102-06797-JJC/RKR/DCE
November 18, 2013

Subject: **Palo Verde Nuclear Generating Station (PVNGS)**
Unit 3
Docket No. 50-530
Response to Request for Additional Information - American
Society of Mechanical Engineers (ASME) Code, Section XI,
Request for Approval of an Alternative to Flaw Removal and
Characterization - Relief Request 51

APS Response to Request for Additional Information (RAI) – Relief Request 51

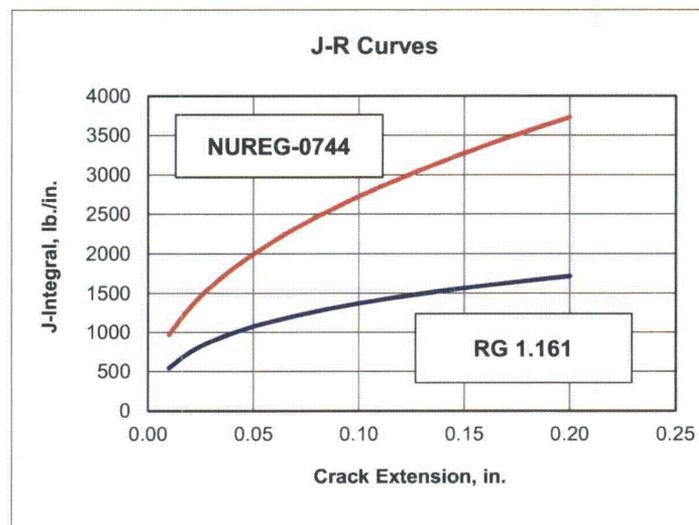
Section 4.1.4 of Attachment 2 [of Relief Request 51] presents the generic J-R curve used in the elastic plastic fracture mechanics (EPFM) evaluation. This J-R curve is based on the J model from Appendix D to NUREG-0744, Vol. 2, Rev. 1, "Resolution of the Task A-11 Reactor Vessel Materials Toughness Safety Issue," 1982. The generic J-R curve models for various low upper-shelf RPV materials are presented in RG 1.161, "Evaluation of Reactor Pressure Vessels with Charpy Upper-Shelf Energy Less Than 50 FT-LB," 1995. Please provide J-R curves based on both approaches to demonstrate that your J-R curve based on NUREG-0744, Vol. 2, Rev. 1 is not significantly different from the RG 1.161 model. Provide correction and reassess your final conclusion if the difference is significant. Please note that the database underlying the J-R model for RPV base metals in RG 1.161 contains not just low upper-shelf energy materials.

Margin factors for the RG 1.161 approach are 0.749 for the Service Levels A (normal), B (upset), and C (emergency), and 1.0 for Service Level D (faulted). The following figure illustrates a lower J-integral resistance to ductile tearing curve provided by the RG 1.161 correlation for normal, upset, and emergency conditions compared to the NUREG-0744 correlation.

Figure 1: Plant Transient - Loss of Secondary Pressure

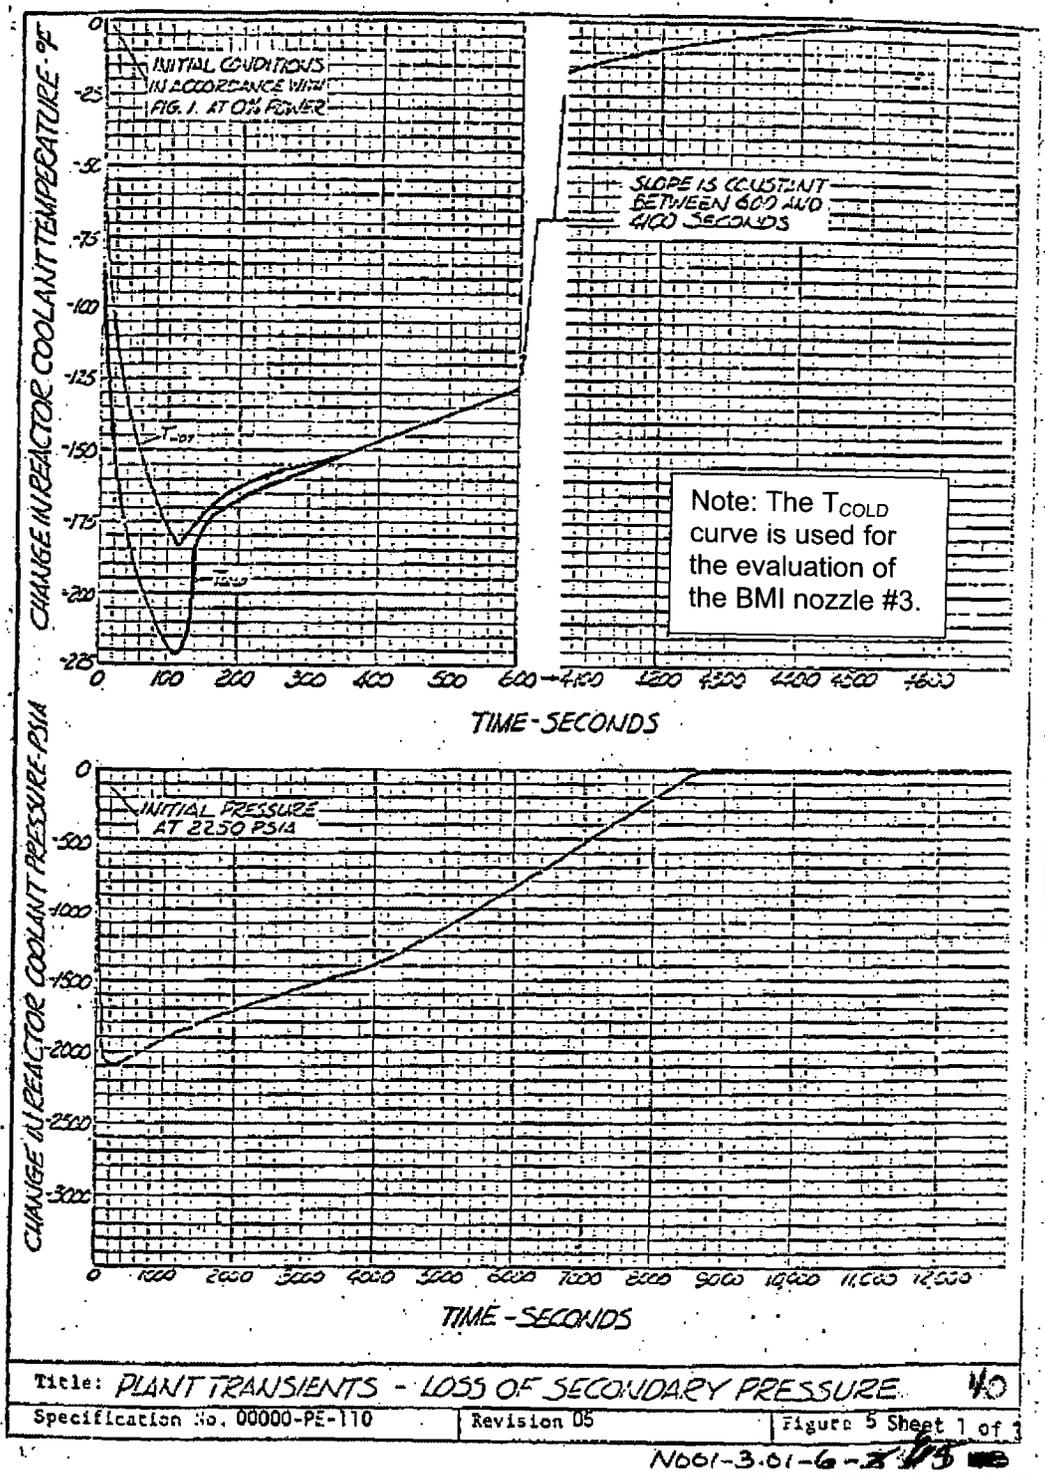
The second faulted condition is the loss of secondary pressure (LSP) transient described in the Palo Verde Updated Final Safety Analysis Report (UFSAR) Table 3.9.1-1. This transient is illustrated by the temperature and pressure time-history plots provided in Figure 1 of Attachment 1 to this enclosure.
